Design Review Committee

Case File Number: ZP170064

January 31, 2018

Location:	1750 Broadway
Assessor's Parcel Numbers:	008 062301300
Proposal:	To construct a 37-story high-rise consisting of 307 residential units with 5,000 square foot of ground-floor retail space including a six-level parking garage above grade to be accessed from 19 th Street.
Applicant:	Rubicon Point Partners / Chris Relf
Phone Number:	(415) 500-6410
Owner:	1750 Broadway LLC
Case File Number:	ZP170064
Planning Permits Required:	Major Conditional Use Permit for buildings over 200,000 square feet in the CBD-P and CBD-C Zone; and Regular Design Review for new construction.
General Plan:	Central Business District
Zoning:	CBD-P / Central Business District Pedestrian; and CBD-C / Central Business District Commercial
Environmental Determination:	Environmental analysis under review
Property Historic Status:	Non-Historic Property
Service Delivery District:	Uptown
City Council District:	3
Date Filed:	07/19/17

GROUND FLOOR PLAN

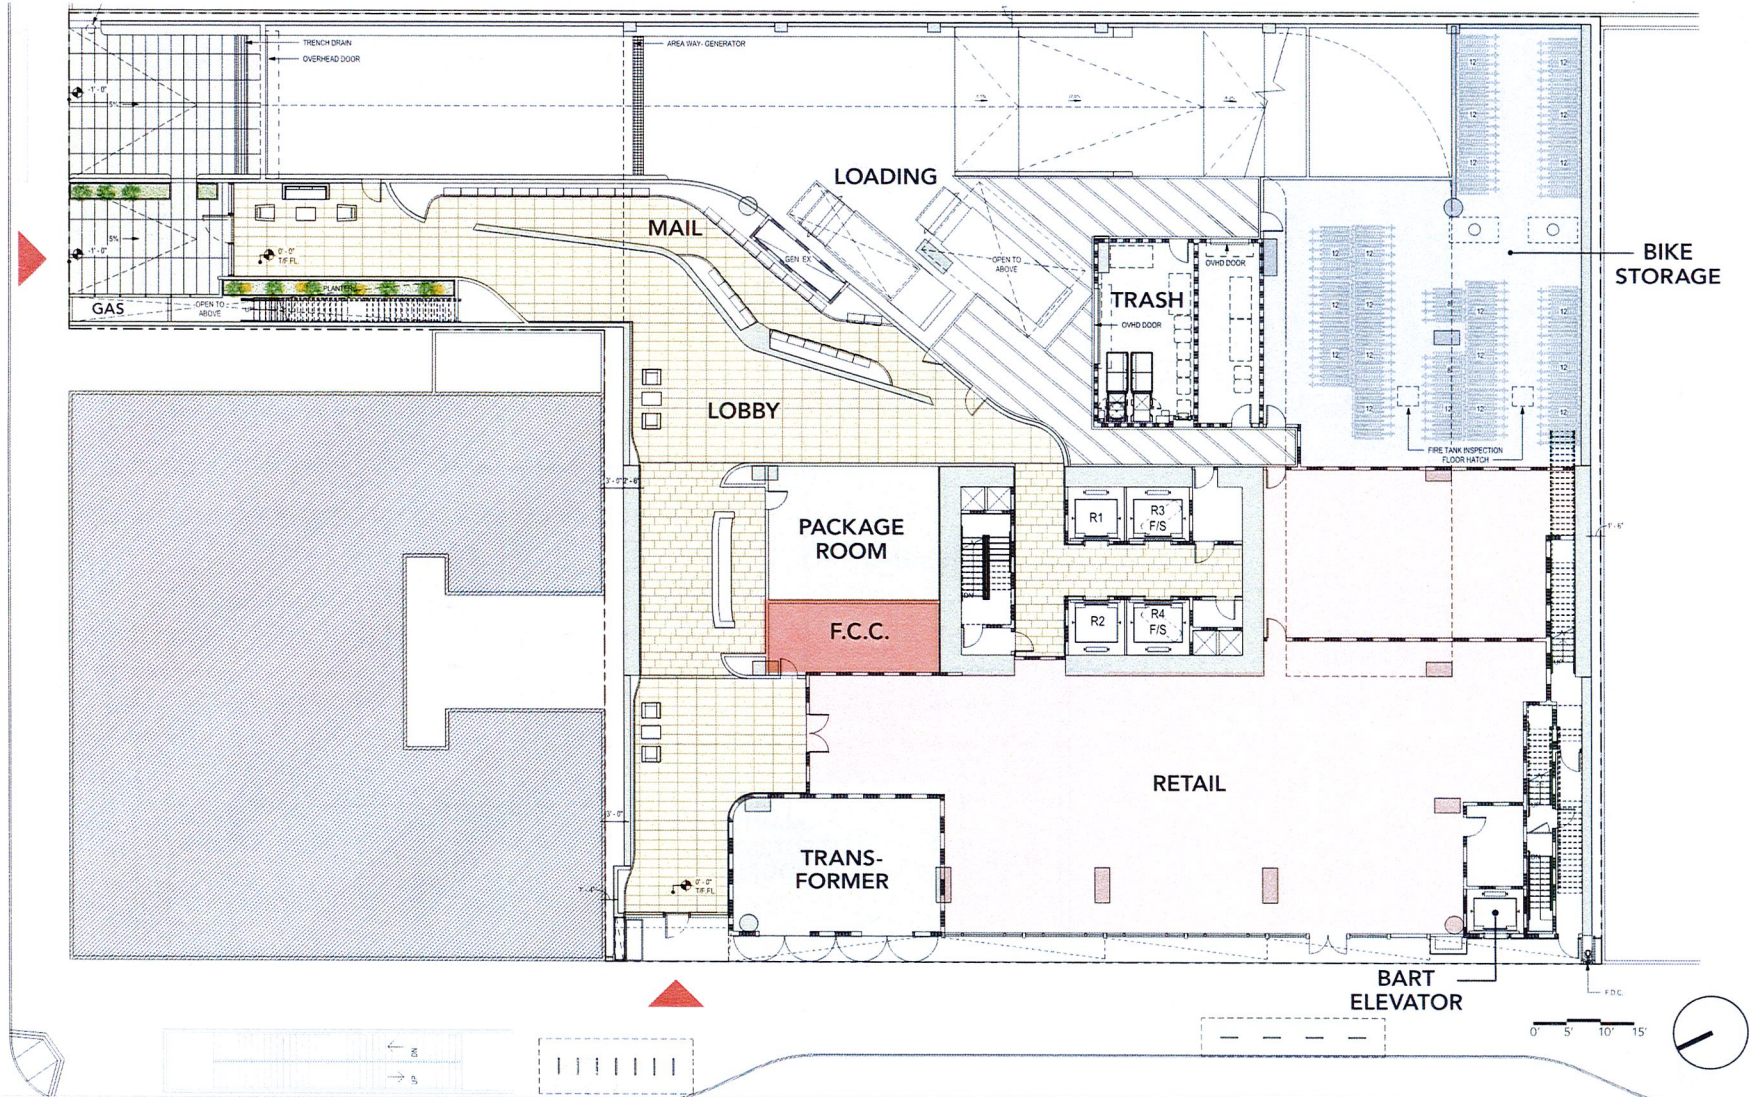
- Consider adding some residential units on level 2 above the retail area and facing Broadway.
- Relocate the transformer room to the rear of the building and at least 30 feet from the street line on Broadway.

- Develop and provide exterior details for any required improvements to the existing BART Station elevator located within the property.
- Distance the proposed short-term bicycle parking area from the north entry/exit BART station.

PODIUM FACADE

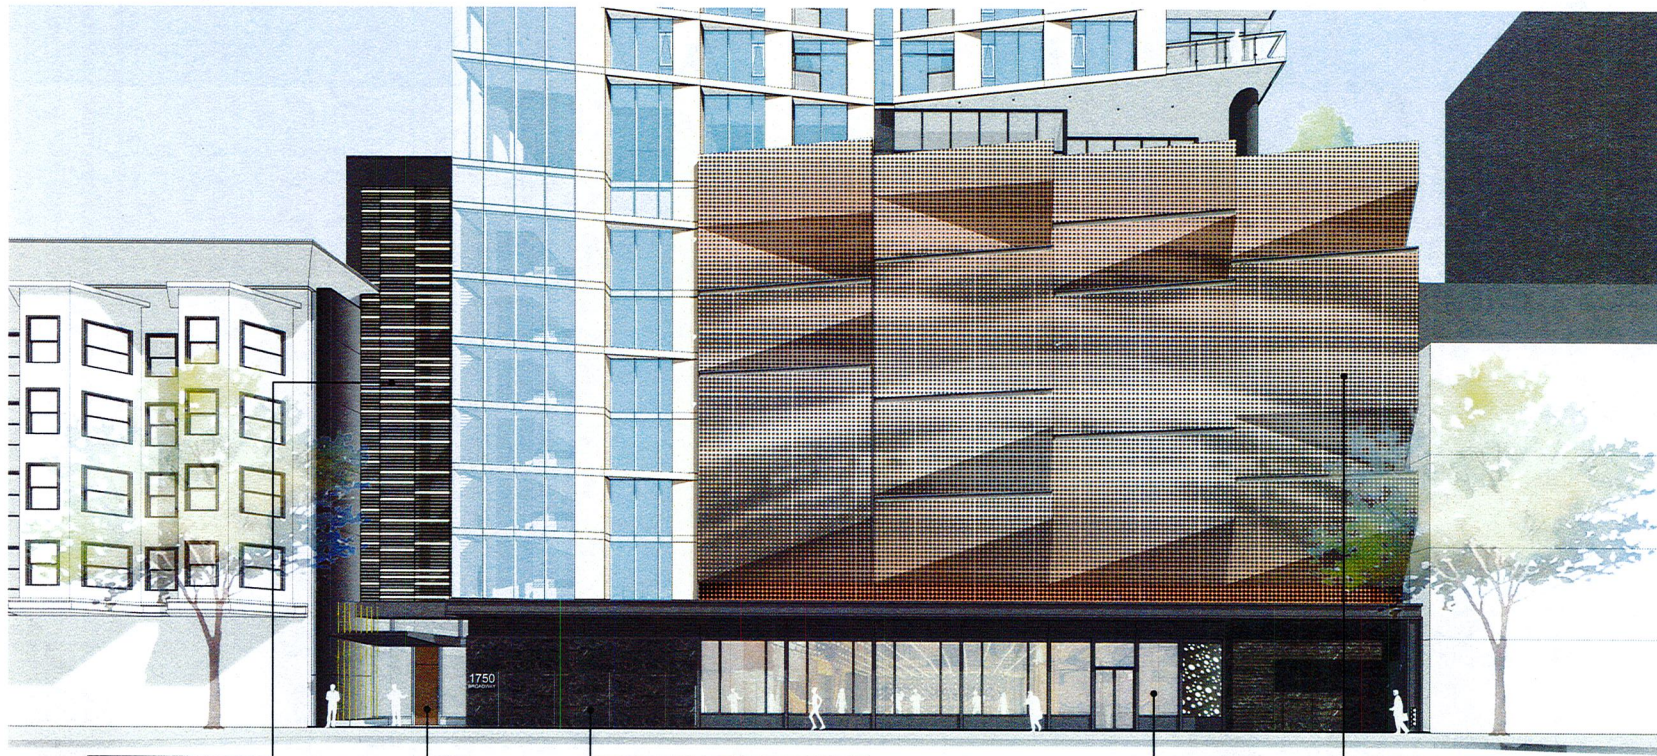
- Develop further the façade wall (garage screen) in front of the six-level parking garage facing Broadway to create a better composition and scale that is compatible to the building tower and that includes interesting design details. Also, limit the verticality of the garage screen to the top of the 7 level. The terrace on the 8 level should use instead a clear glass railing for transparency.
